UNITED STATES
NUCLEAR REGULATORY COMMISSION
WASHINGTON, D. C. 20555

ARKANSAS NUCLEAR ONE - UNIT NO. 1

AMENDMENT TO FACILITY OPERATING LICENSE

Amendment No. 34
License No. DPR-51

FIGURE 6.2-1

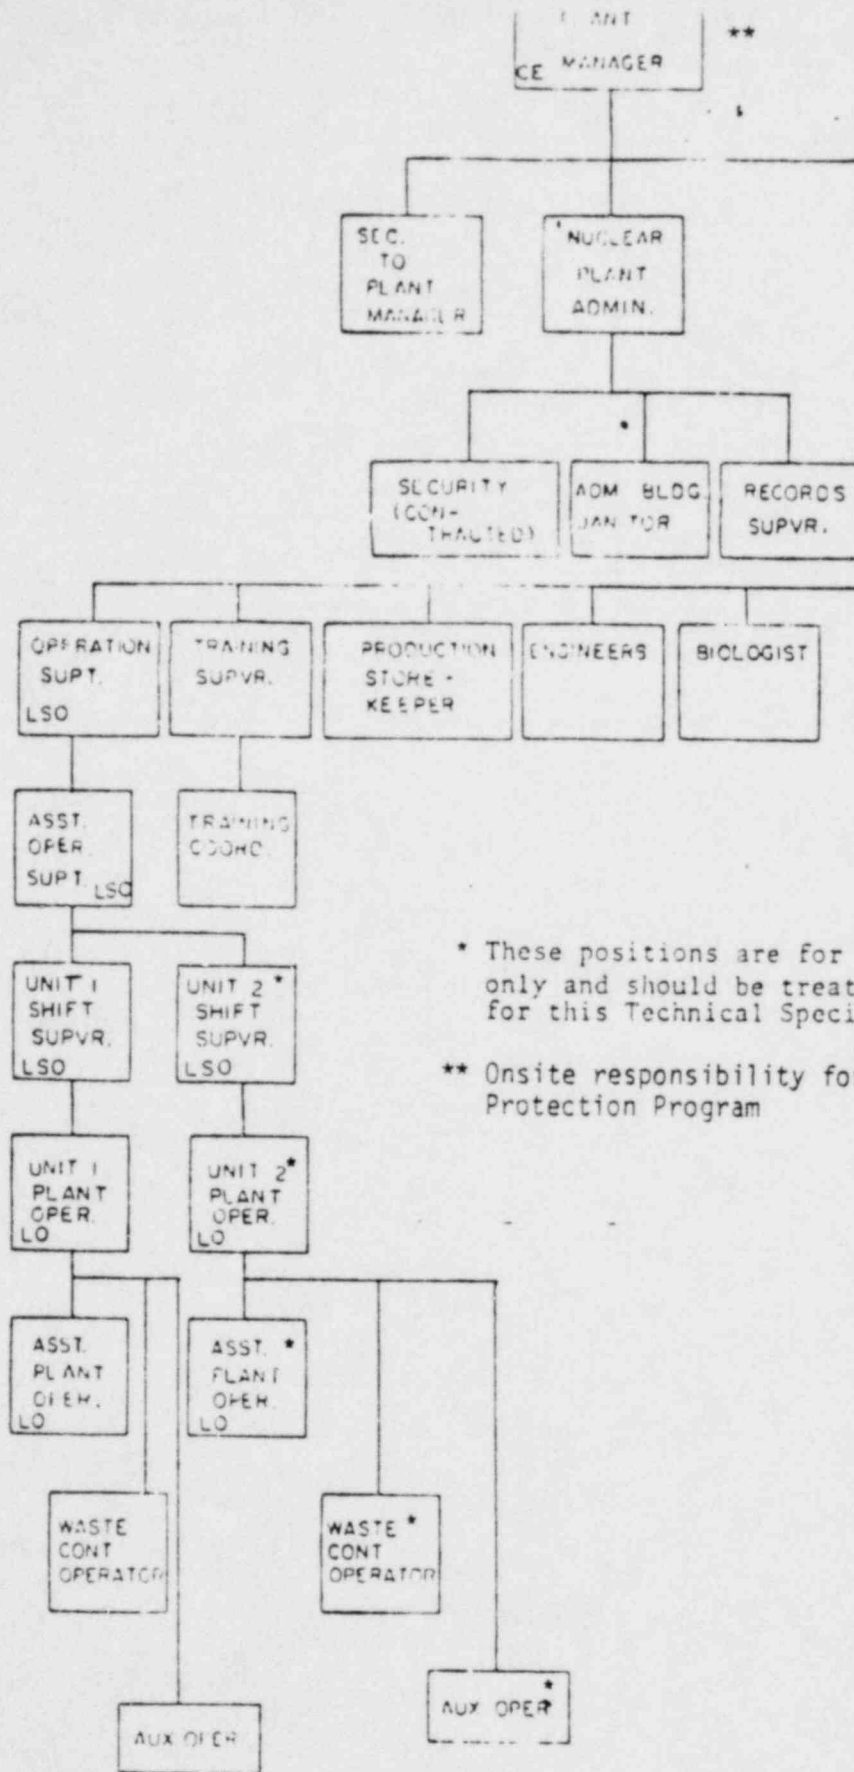
- 6.2.1 The offsite organization for facility management and technical support shall be as shown on Figure 6.2-1.

** Onsite responsibility for Fire Protection Program

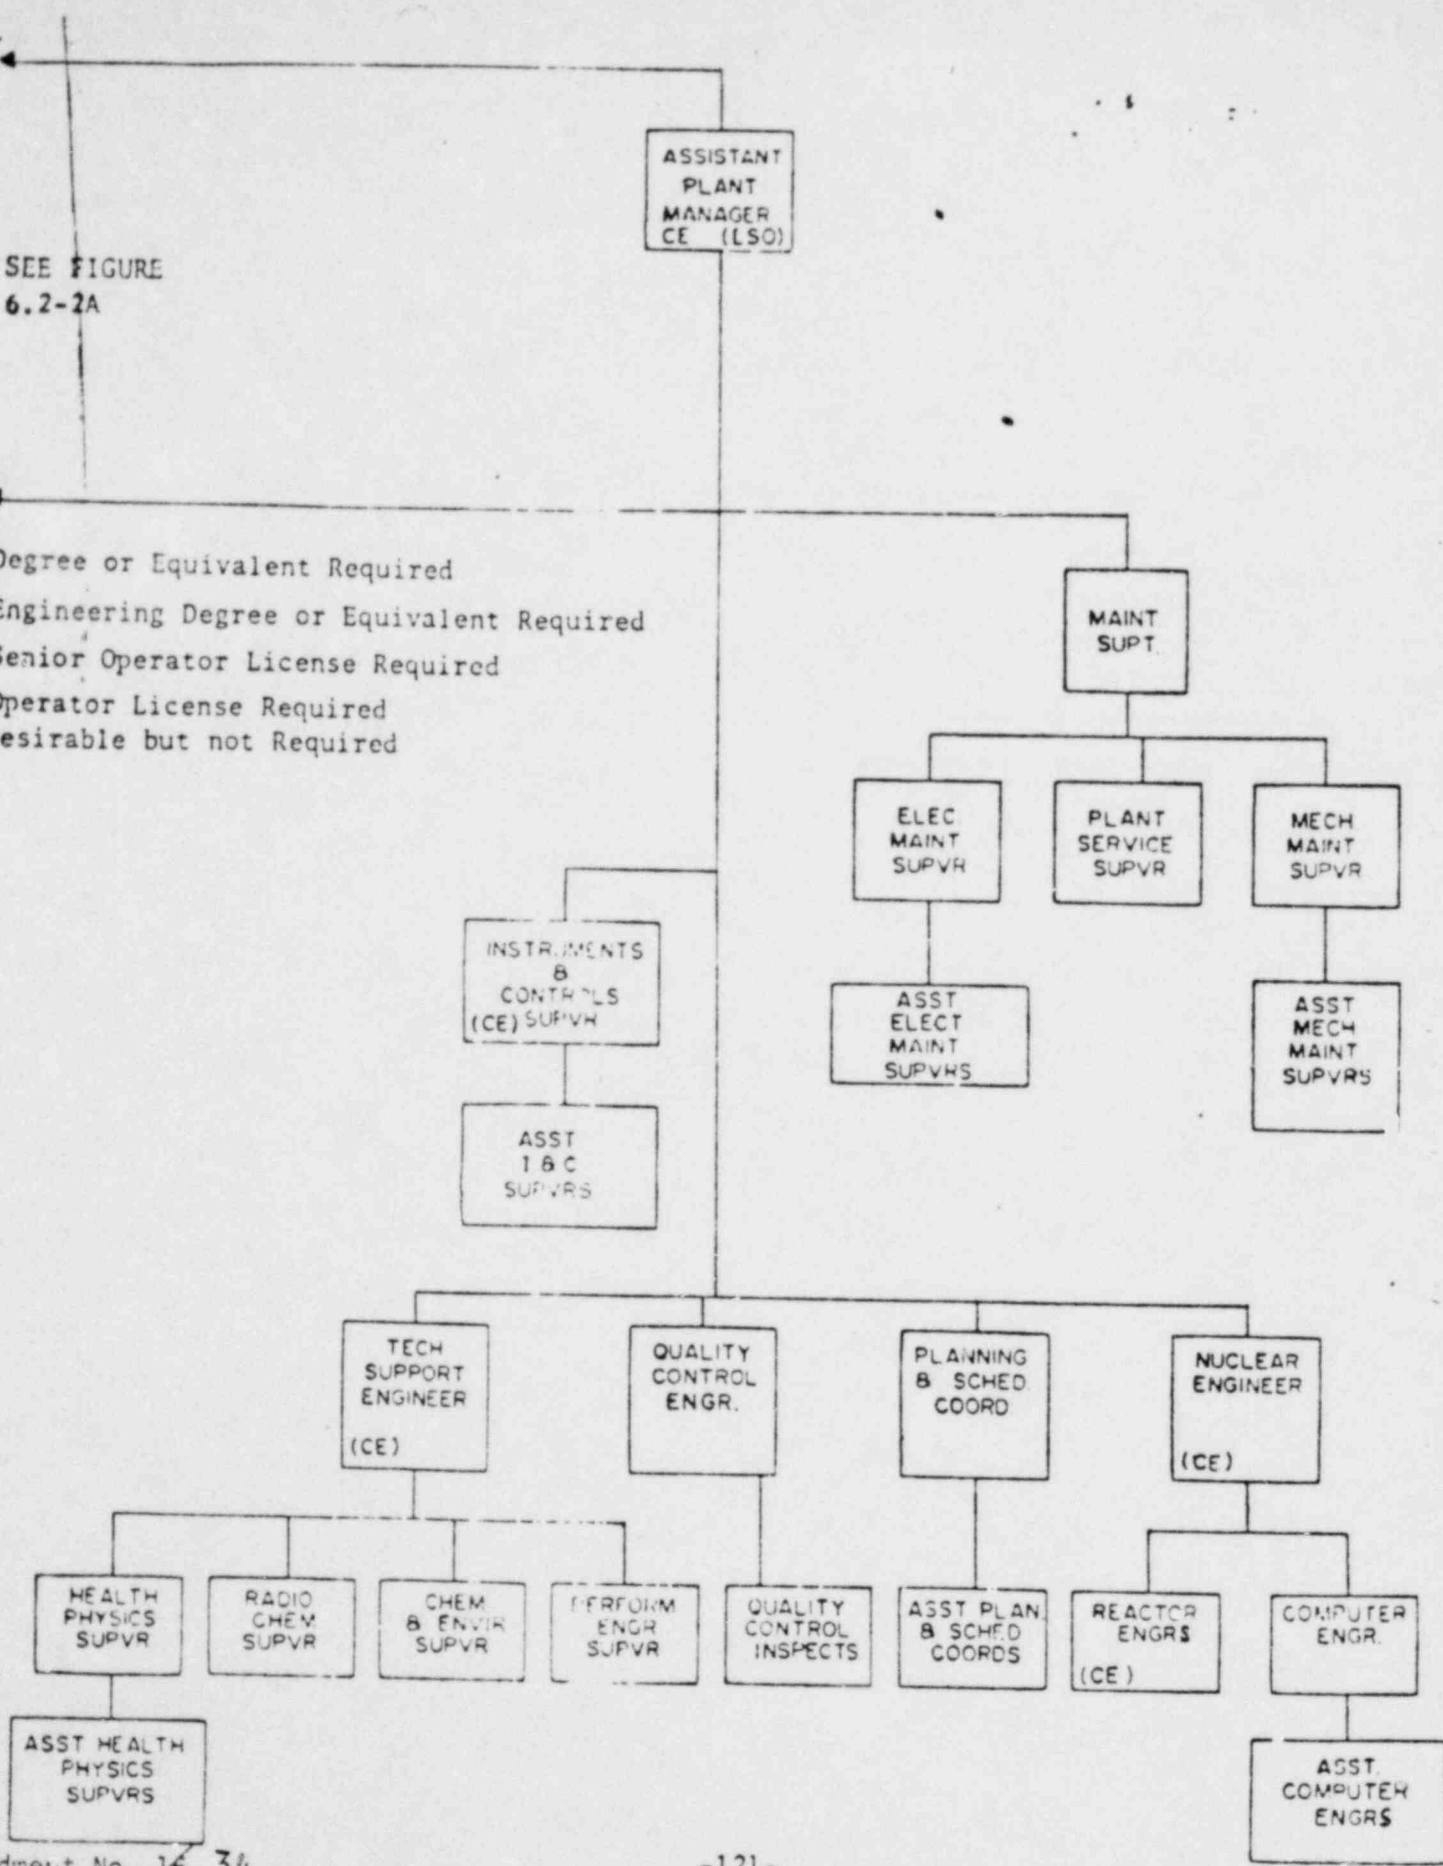
- 6.2.2 The Facility organization shall be as shown on Figure 6.2-2A and 6.2-2B and each on duty shift shall be composed of at least the minimum shift crew composition shown in Table 6.2-1.

- C - Degree or Equivalent Required
- CE - Engineering Degree or Equivalent Required
- LSO - Senior Operator License Required
- LO - Operator License Required
-) - Desirable but not Required
